11/16/81
⚠ REVISION – Addition of Temporary Pond at London St Outlet to Accomodate Runoff from London St.

ACADEMY SQUARE

TITLE: GRADING/DRAINAGE PLAN

SHEET 3 OF 6

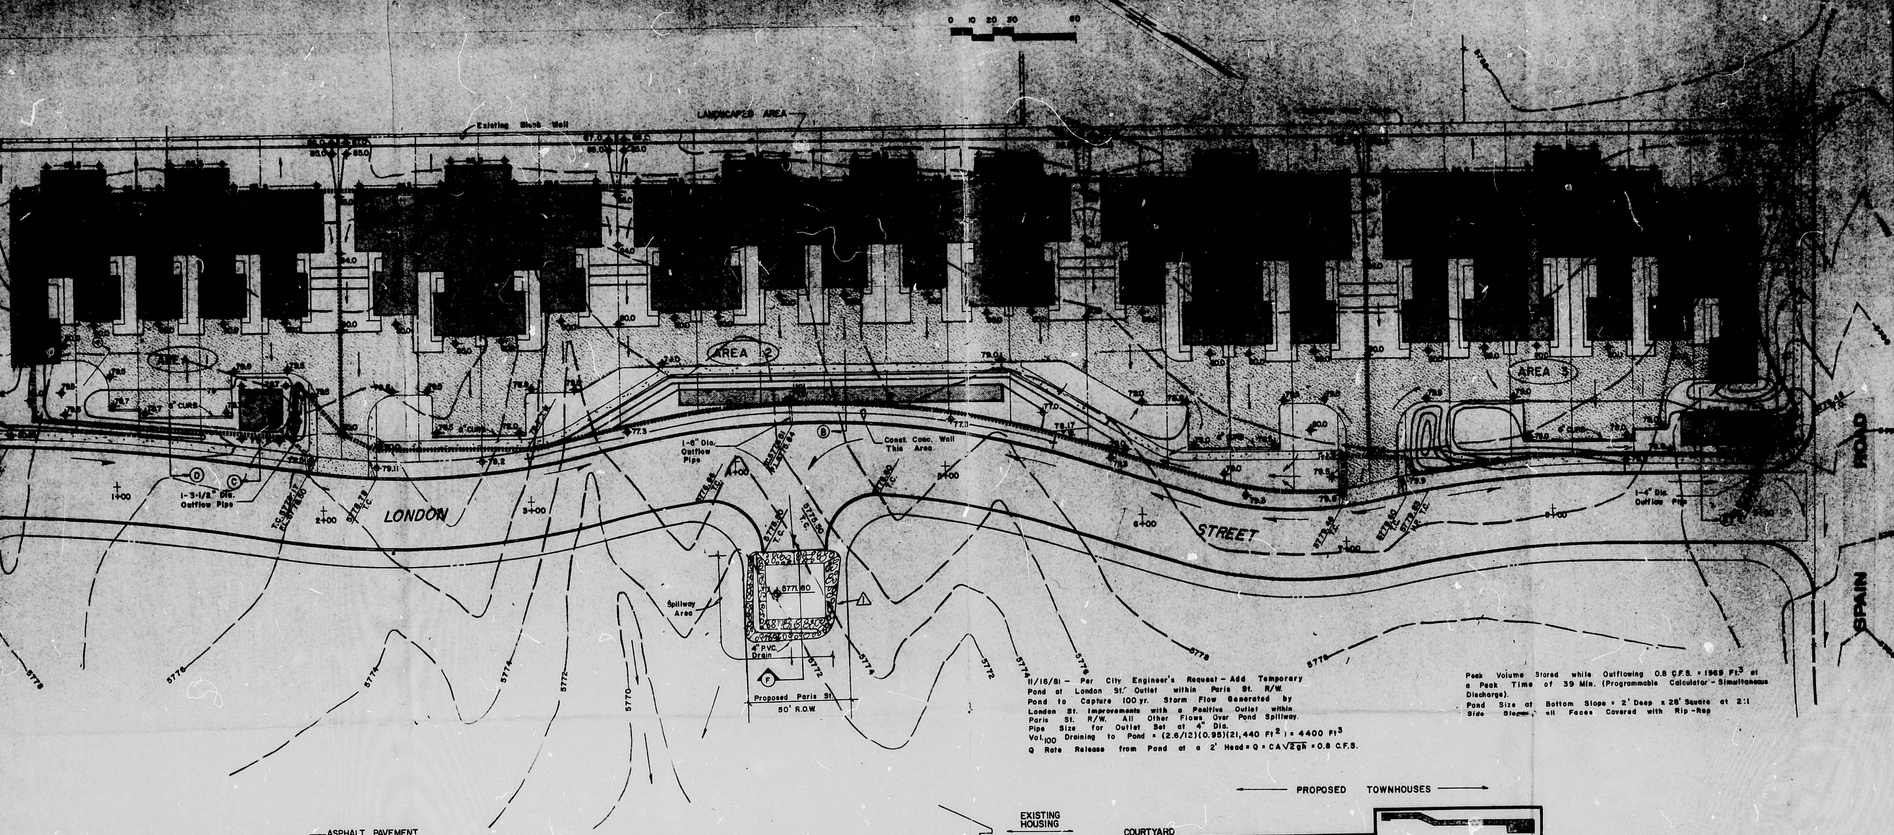
11/16/81 – Per City Engineer's Request – Add Temporary Pond at London St. Outlet within Paris St. R/W.
Pond to Capture 100 yr. Storm Flow Generated by London St. Improvements with a Positive Outlet within Paris St. R/W. All Other Flows Over Pond Spillway.
Pipe Size for Outlet Set at 4" Dia.
Vol.100 Draining to Pond = (2.6/12)(0.95)(2)(440 Ft^2) = 4400 Ft^3
Q Rate Release from Pond at a 2' Head = Q = CA$\sqrt{2gh}$ = 0.8 C.F.S.

Peak Volume Stored while Outflowing 0.8 C.F.S. = 1969 Ft^3 at a Peak Time of 39 Min. (Programmable Calculator – Simultaneous Discharge).
Pond Size at Bottom Slope = 2' Deep x 28' Square at 2:1 Side Slopes, all Faces Covered with Rip-Rap
